STAFF REPORT ORCHARD VISTA SUBDIVISION P-2023-01

TO: Douglas County Hearing Examiner
FROM: Douglas County Land Services Staff
RE: Orchard Vista Plat Subdivision (P-2023-01)
DATE: May 9, 2024

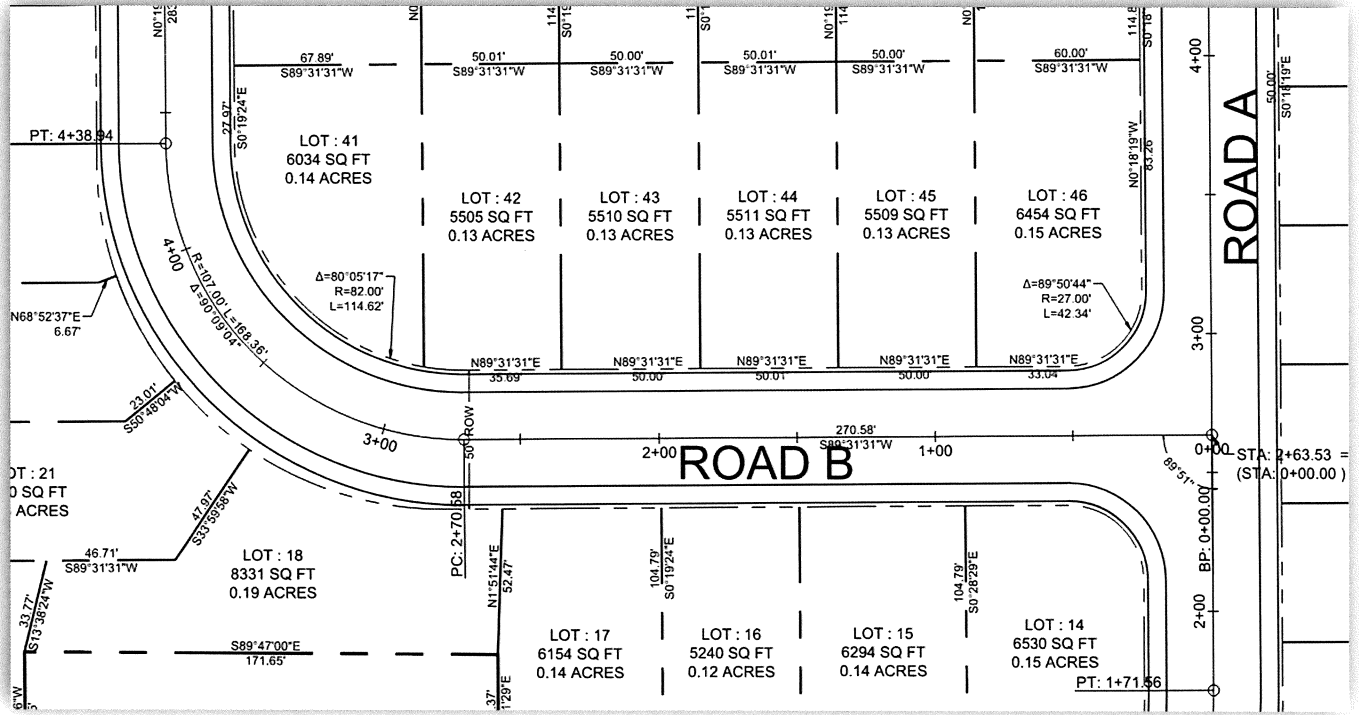
Douglas County Transportation and Land Services received your request for an alternative to the East Wenatchee Municipal Code (EWMC). Your request (dated March 28, 2024) for an alternate has been reviewed and accepted by the County Engineer as conditioned below:

1. It is acceptable to construct roadway improvements along the project's proposed Road B in substantial conformance with the layout presented in the request dated March 28, 2024 utilizing a design speed of 20 MPH for the centerline radius directly adjacent to Lots 18-23, 41 & 42 (see attached exhibit). This alternate allows for the reduction of design speed and associated horizontal centerline radius.

The attached memorandum of acceptance will be included within the project file. The proposed request appears to comply with the goals and policies of the *Greater East Wenatchee Area Comprehensive Plan*.
